KHUMANI PASTE DISPOSAL FACILITY

INDEPENDENT TAILINGS REVIEW REPORT No 3

December 2022

Photo 1: Deposition in Compartment 3B

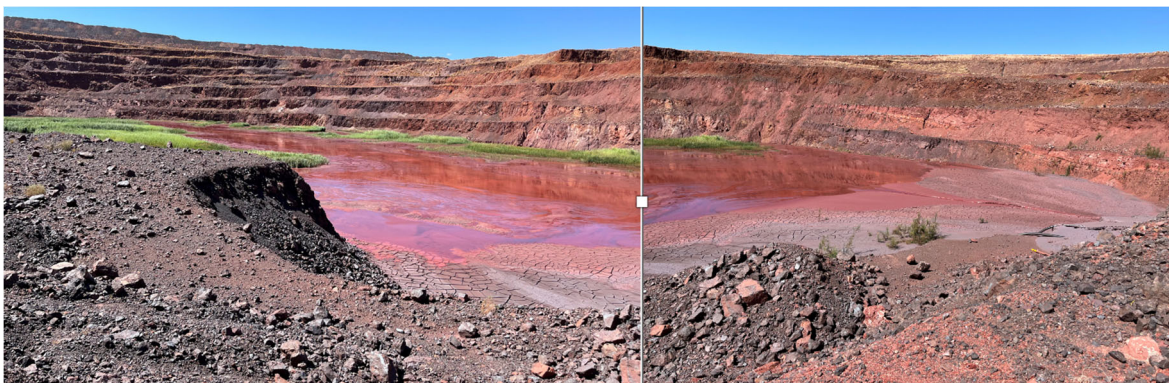
Water recovery from the active compartments, and specifically from Compartment 3B, does not appear to be optimal as beach formation is relatively flat, resulting in pools which are not consistently centered around the barge pump inlets. The following measures are proposed by the EoR and the Operating Contractor:

- Introduction of Turret intake devices which will allow the intake of water at shallow depth;
- Experimenting with spray-bar deposition in Compartment 3B to improve beach formation.

The ITRB supports the proposed measures.
